<b>Title: MTO2017 Oil Breather hose routing</b>		
<b>AG-SB-2023-01-C-EN</b>	<b>Effective Date: 01.04.2023</b>	<b>Compliance Category:</b>  <b>A - MANDATORY</b> <b>B - RECOMMENDED</b> <b>C - OPTIONAL</b>
<b>Applicability</b>		
<b>Aircraft type &amp; model:</b>  <b>MTO2017</b>	<b>Affected Serial number(s):</b>  <b>All MTO2017 produced before 07/2021</b>	
The maintenance manual to be referenced is this stated or subsequent issue.		As per AutoGyro website
This form is the response from AutoGyro GmbH either against a problem found in the product in service requiring a containment or rectification action, or as service information for aircraft modification incorporation. For help, contact <a href="mailto:airworthiness@auto-gyro.com">airworthiness@auto-gyro.com</a> .

Illustrations

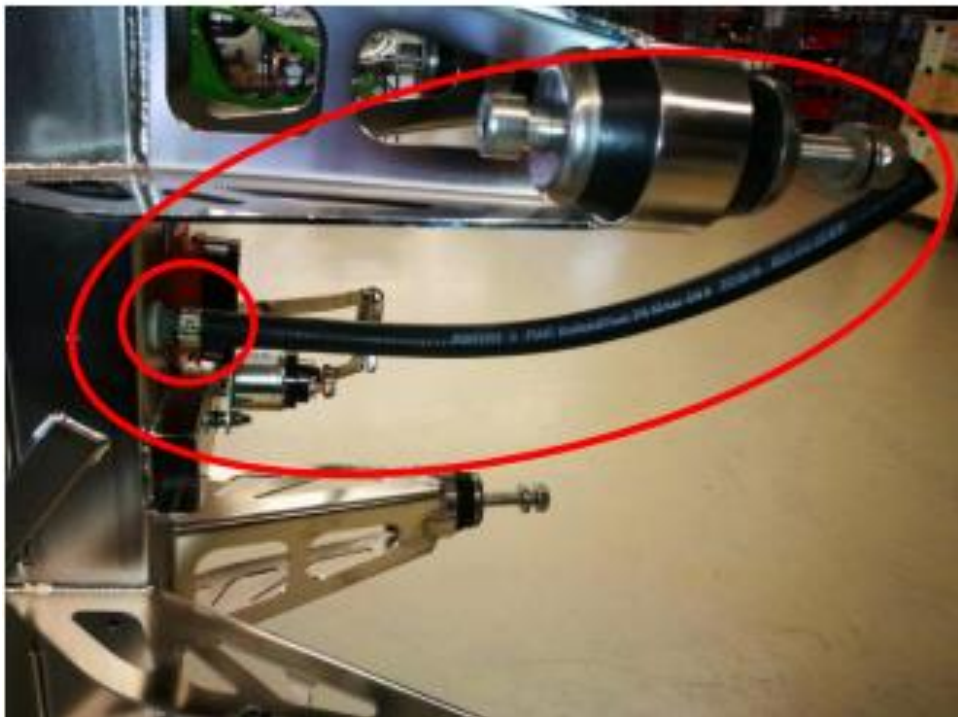
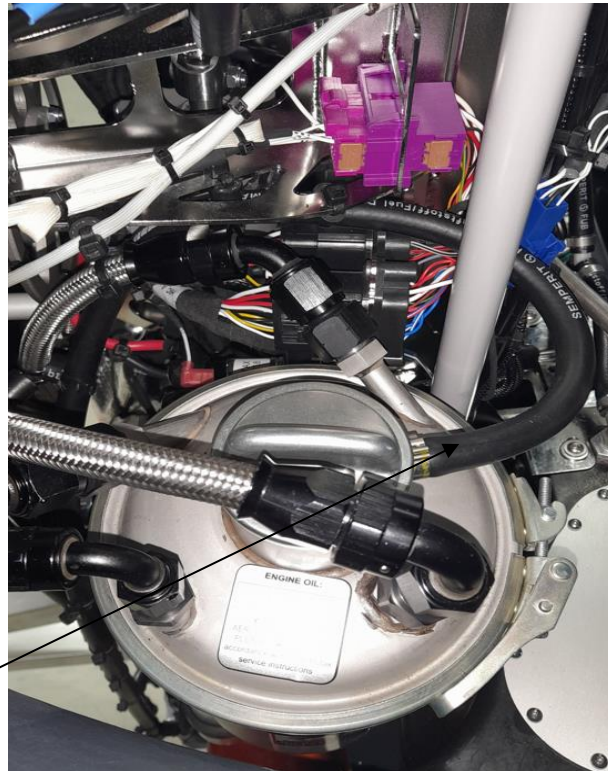
The oil breather hose is connected from the top of the oil tank into the stainless steel frame of the aircraft. The oil vapour of the engine should go overboard via the frame below the aircraft. Due to the fact that the frame has several openings in different places, it has been found in service that, in some circumstances, the oil vapour may be vented such that the occupants notice an oil smell.

This situation has been improved by extending the oil vent hose such that it leads directly to the lower end of the airframe cell where the oil vapour is blown away beneath the aircraft.

Old version of oil breather hose routing:

New routing of oil breather hose:

Remove the old oil breather hose from the tank and the mast. Install the new oil breather hose on the oil tank and fix it as shown on the pictures below.

Ensure that there is a cut in the hose near the tank in the same position as the removed hose. This cut is to allow the engine to oil system to breath in the event that the moisture in the lower part of the breather tube freezes in flight.
